DESIGN REVIEW BOARD AGENDA
NOTICE OF MEETING

Report No: DR-2026-01-19-6a

Report Title:
Design Review Recommendation – 1B West Street (PID 365833)

Attachment "D" – Architectural Elevations and Floor Plans (original package)

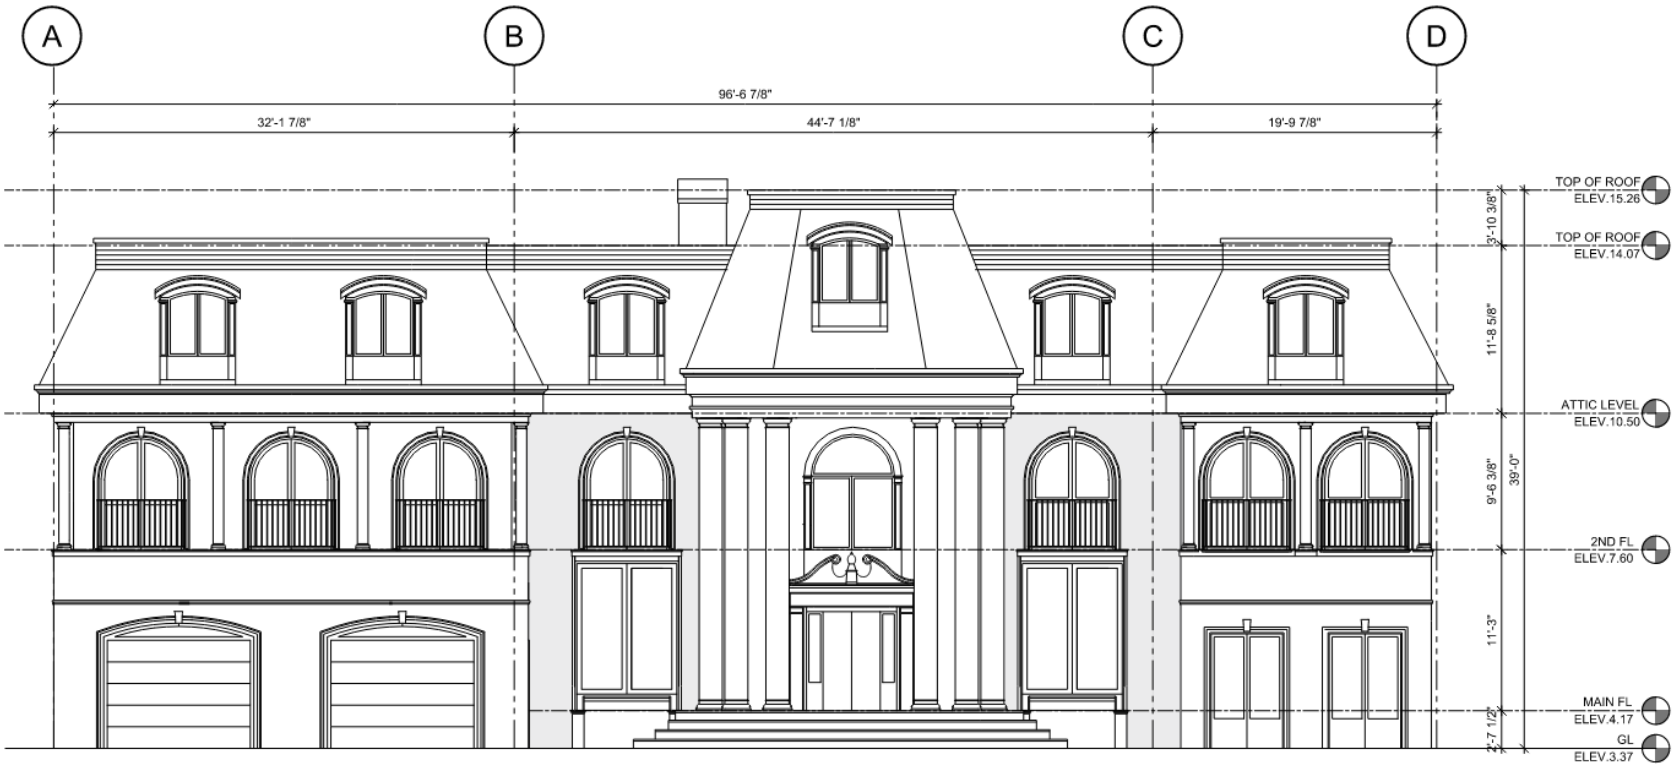
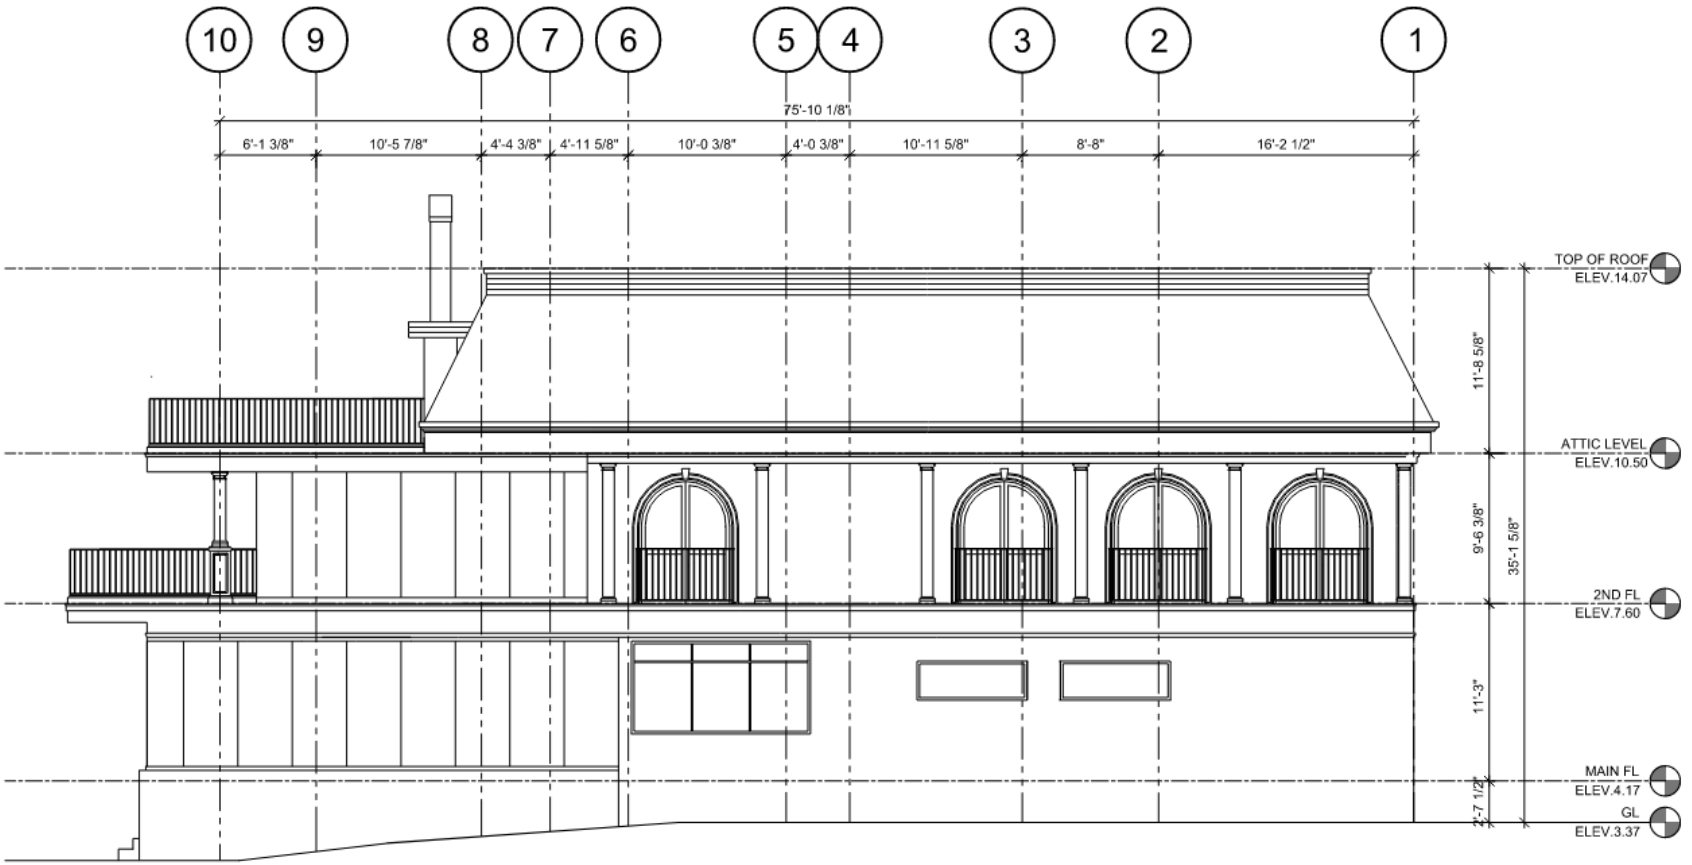
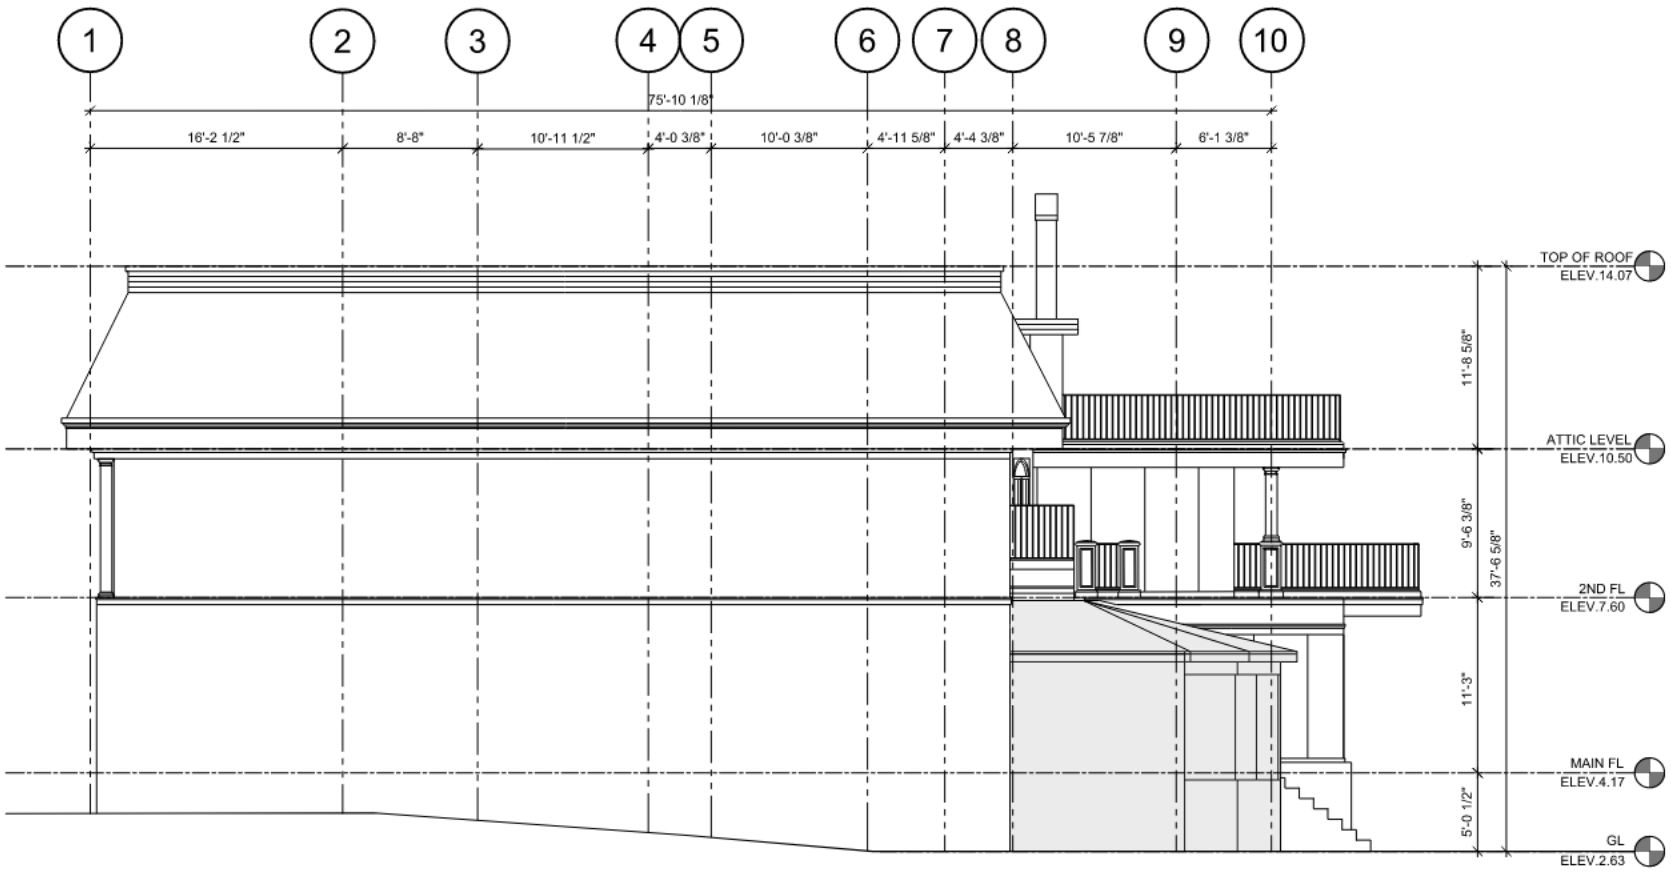
The recently submitted proposal to renovate and alter the property includes an addition of a 3rd storey, substantial additions on the north and south sides of the building and the addition on the rear façade

of a series of 2nd and 3rd storey balconies with a mixture of modern style glass panel windows and arched windows. This work would result in the removal of the sun porch and garage which in staff's opinion would significantly alter the character-defining elements of the property.

Existing Architectural Details Georgian Style	**Proposed Architectural Details Italianate Style**
Demolition of the south wing, 2 storey flat roofed sunroom.	Replacing it with a 3 storey addition containing a garage on the 1st storey.
Hipped roof in Georgian style.	Converting it to a mansard roof in Italianate style.
Existing arched windows on the 1st storey of the sunroom and existing garage are in keeping with Georgian style. The main body of the house contains 6 over 6 sash windows with Boston headers in Georgian style.	Replacing these with arched windows in Italianate style that have keystones and arched moldings. The front façade main body of the house would contain a series of arched windows on the second and 3rd storeys and the 1st storey would contain 2 prominent garage doors and what appears to be floor to ceiling casement windows.
Georgian style shutters are being removed.	Replacing with what appears to be either Juliet balconies or shutters on the lower half of the arched windows on the 2nd storey.

2 storey front portico in Georgian style containing a semi-circle window with a sunburst pattern being removed.	Replacing with a 2 storey Italianate covered porch with additional living space above on the 3rd storey. The change featuring a centre mansard roof with two Italianate style windows on the 2nd and 3rd stories.
Existing south wing (sunporch) and north wing (garage) are 1 ½ stories and are setback from the main body of the building with its prominent front portico. These wings are set back from the main body of the house and are subordinate allowing the front portico to be the main feature of the house along the streetscape.	The 3 storey additions to the south and north wings extend past the existing main body of the house and sit level with the portico making it difficult to discern what portion of the building is original diminishing the prominence of the centre portion of the front façade.

In addition to the changes listed above, staff are unable to determine what form of cladding is proposed to be used on the exterior of the renovated building. The building currently has several chimneys which lend to its Georgian character. The proposed architectural elevations show one chimney remaining. One of the most significant changes is to the mass, scale and bulk of the building. The home is currently a 2-storey dwelling with a hipped roof. The elevations show an additional story being added but of note is the size of the additions particularly the one on the south end of the building. The additions almost double the size of the building which completely changes the overall shape and mass of the building. Such a significant change to the overall shape and mass of the building diminishes the prominence of the building's appearance on the site and the streetscape.
